APPLICATION EP/25/0846 NUMBER

Applicant: Fairfax Aspire Ltd

Location: Farm View, Langley Vale Road, Epsom, KT18 6AP

Development: Outline application for up to 110 dwellings including affordable homes (all

Figure 4.1: Appropriate protection from motor traffic on highways

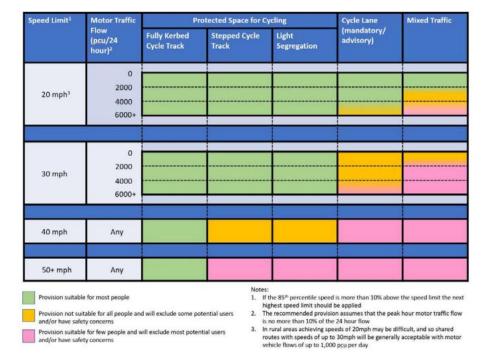
Provision of an on-carriageway cycle lane would not be appropriate for these locations given the number of cyclists who may be excluded as a result – this facility is only recommended for low traffic/20mph locations, while Headley Road at the location proposed is a narrow, rural 40mph road, routinely carrying higher speed vehicular traffic.

The provision of segregated road along this stretch would require land that is not currently available to the best of my knowledge, and as such practically delivering this provision is not likely.
